**MOD2022/0019**

**SITE ANALYSIS PLAN**

REV:	DATE:	DESCRIPTION:
A	12.01.2022	MOD/SEC 4.55 DRAWINGS ISSUED
B	14.01.2022	AMENDMENTS TO MOD DRAWINGS

**PROPOSED ALTERATIONS AND ADDITIONS**  
**4 FARNELL ST, SOUTH CURL CURL**  
**CLIENT:**  
**VICKY & MARK**

CARPORT WEST ELEVATION

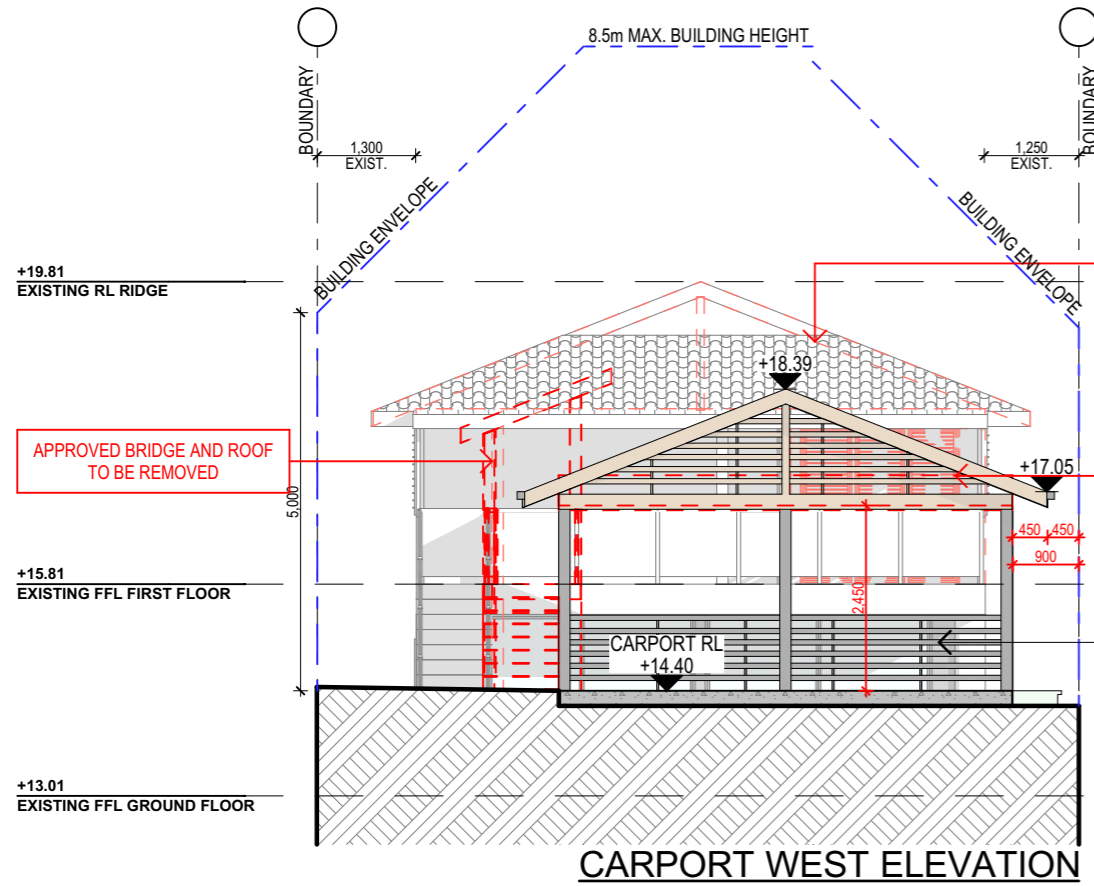
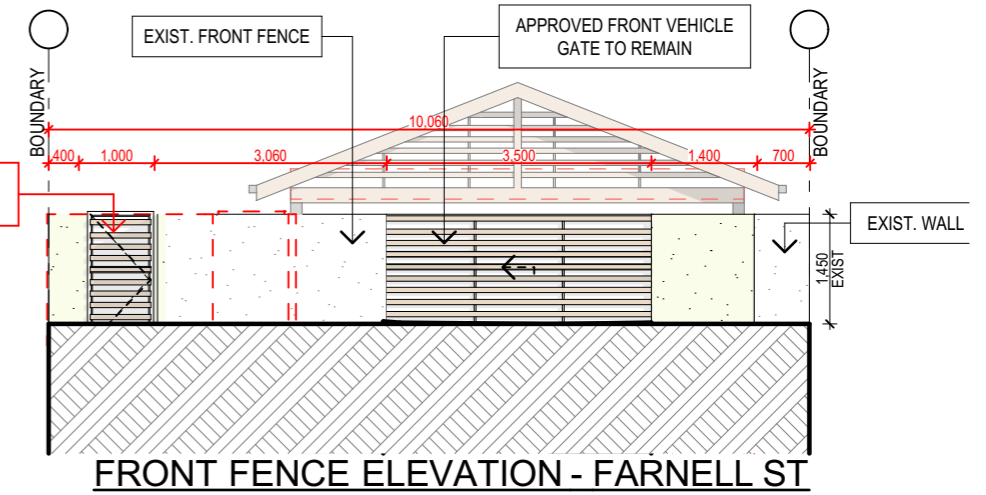
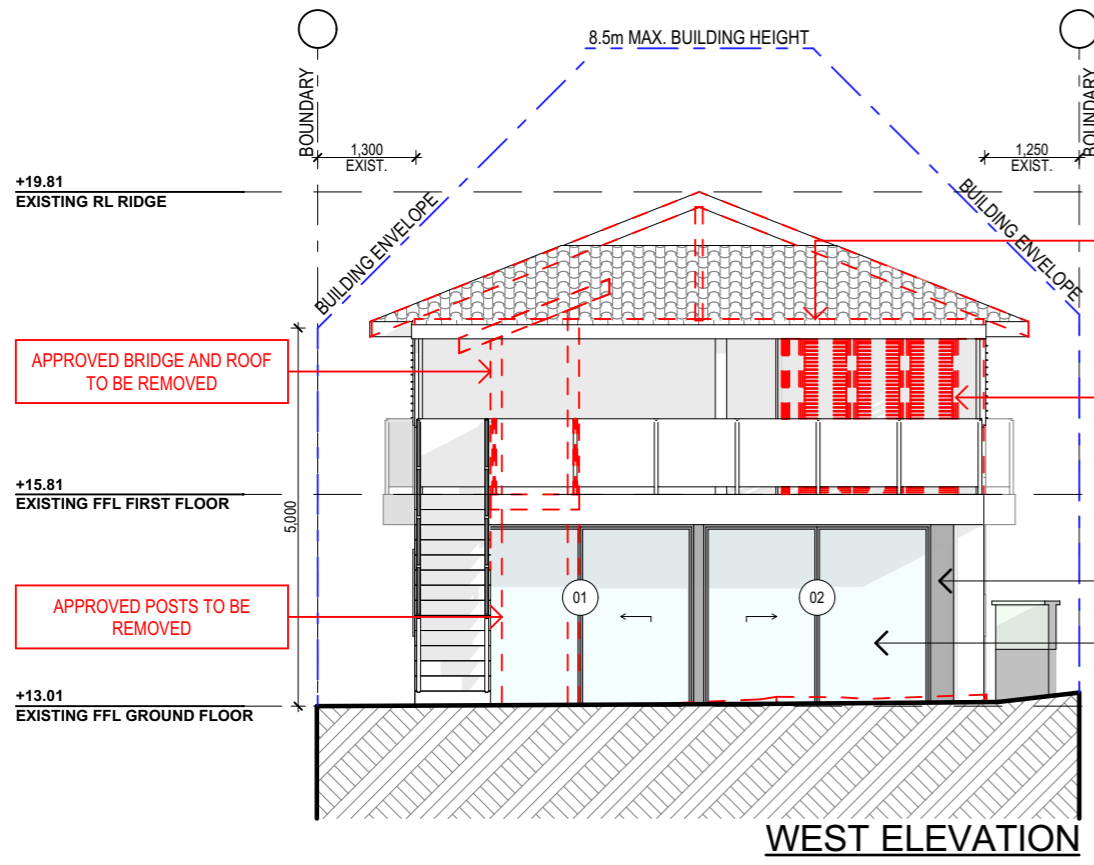
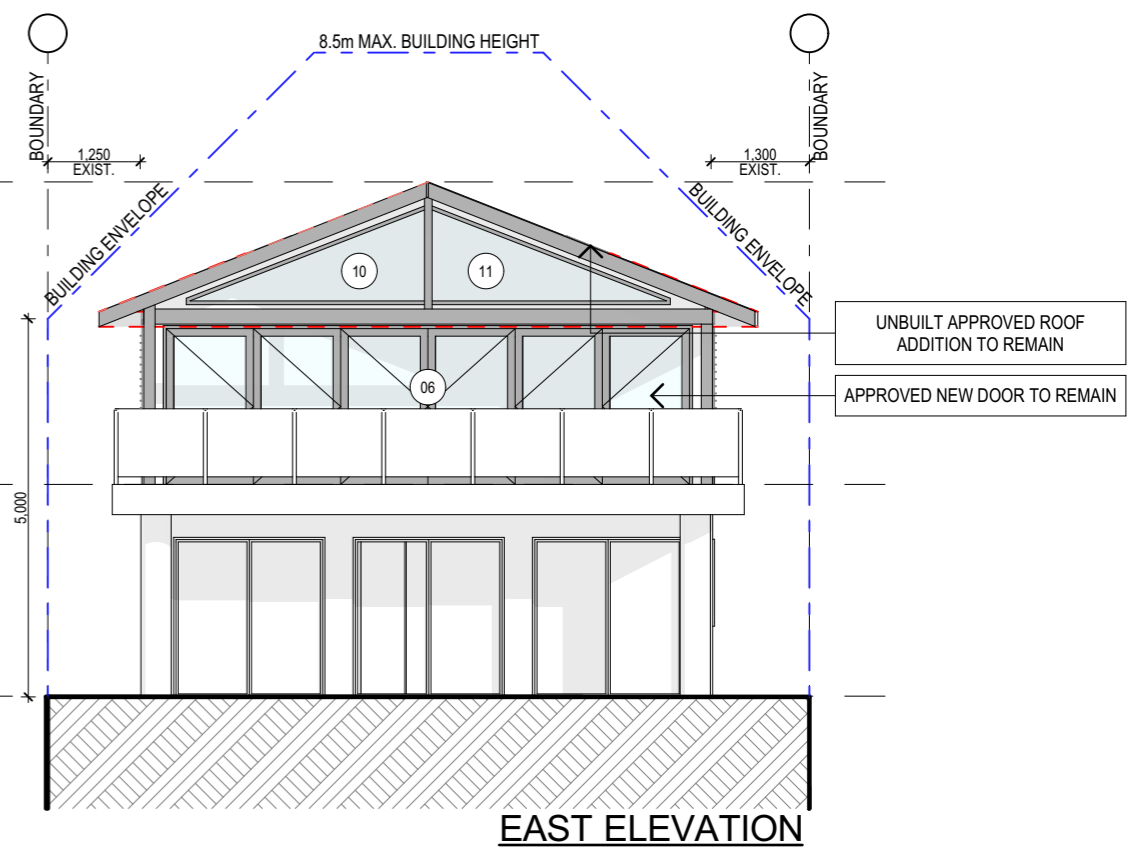
APPROVED GABLE ROOF ADDITION TO BE REMOVED - EXIST. ROOF TO REMAIN UNCHANGED

APPROVED CARPORT ROOF TO BE REDESIGNED TO A GABLE ROOF - COLORBOND TO MATCH EXIST. HOUSE - GREY WINDSPRAY

APPROVED CARPORT SLAB AND STRUCTURE TO REMAIN

APPROVED FRONT FENCE AND GATE TO BE SLIGHTLY MOVED

APPROVED GABLE ROOF ADDITION TO BE REMOVED - EXIST. ROOF TO REMAIN UNCHANGED

APPROVED NEW WALLS (BED 2) TO BE REMOVED

APPROVED ENCLOSED CARPORT TO REMAIN

APPROVED NEW DOOR TO REMAIN

APPROVED BRIDGE AND ROOF TO BE REMOVED

APPROVED POSTS TO BE REMOVED

EAST ELEVATION

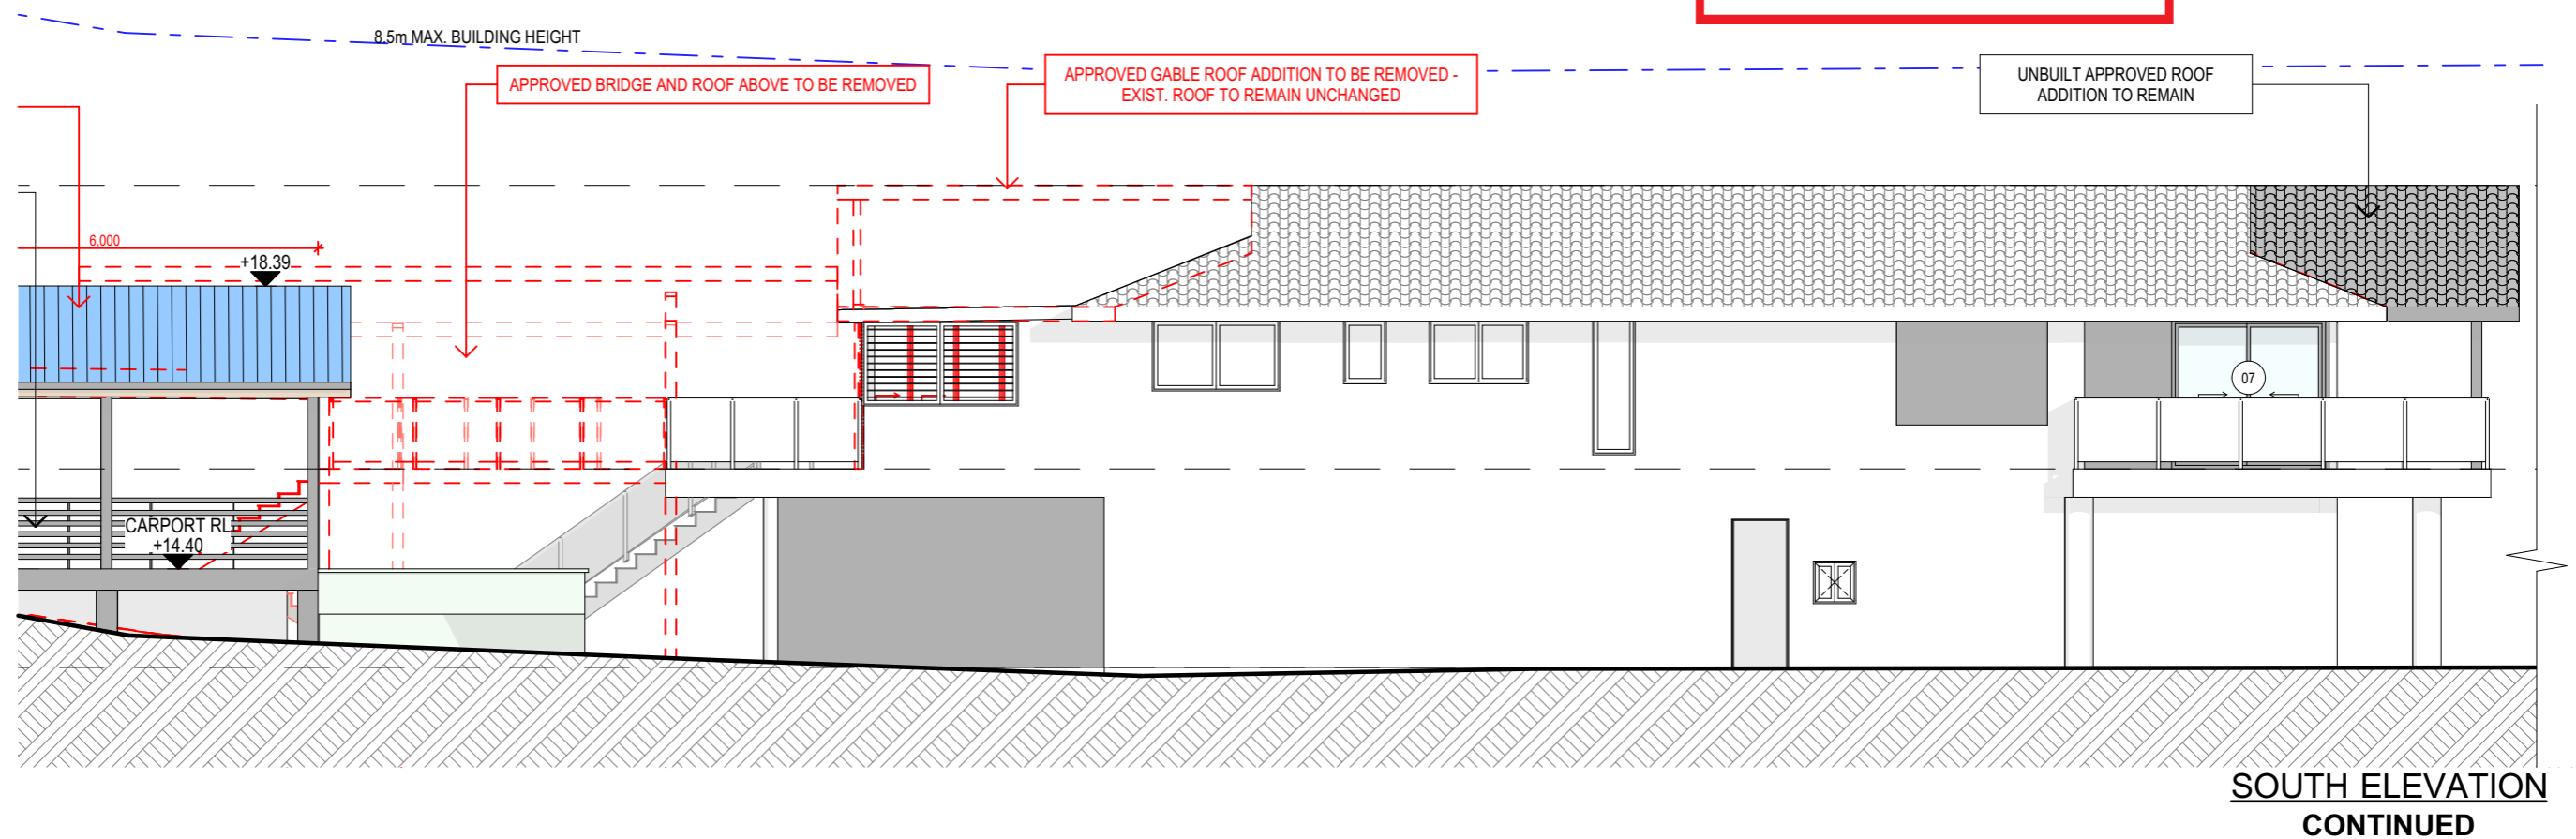
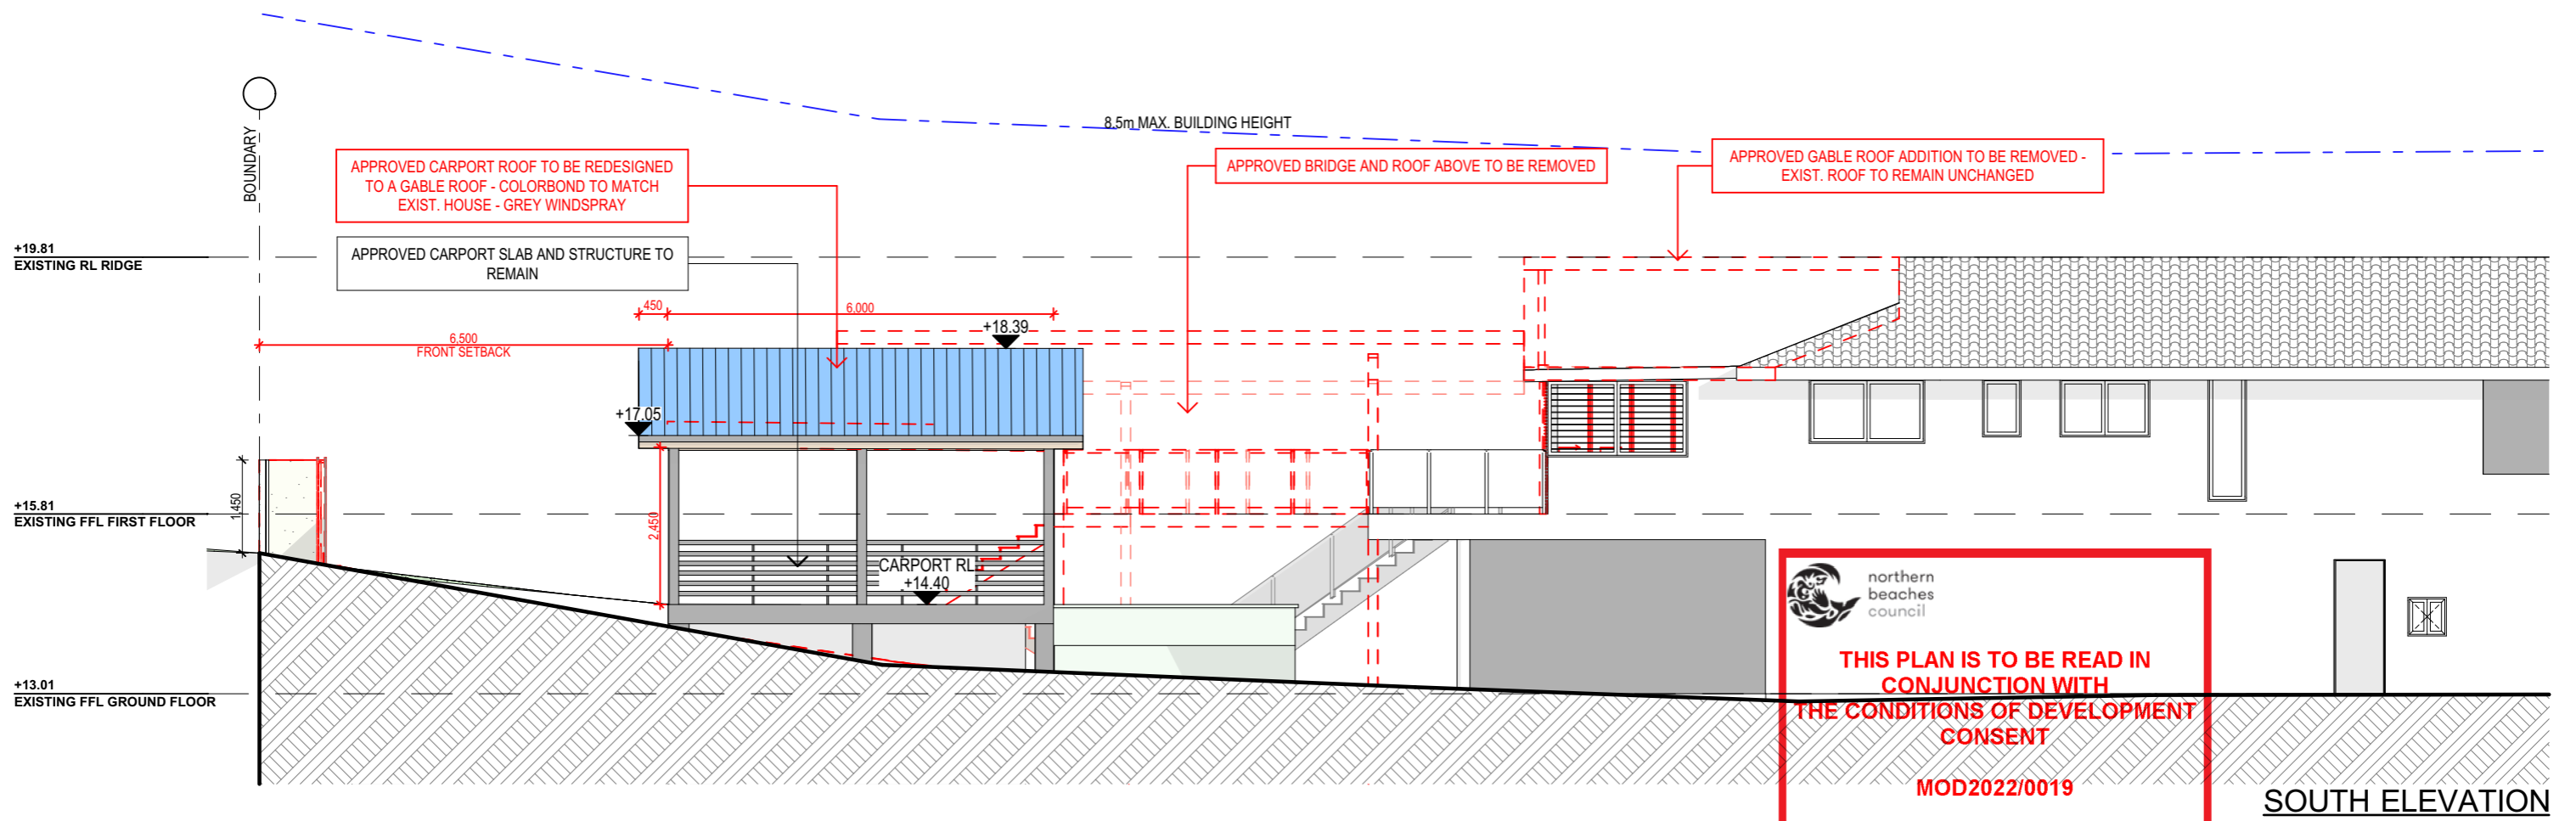
UNBUILT APPROVED ROOF ADDITION TO REMAIN

APPROVED NEW DOOR TO REMAIN
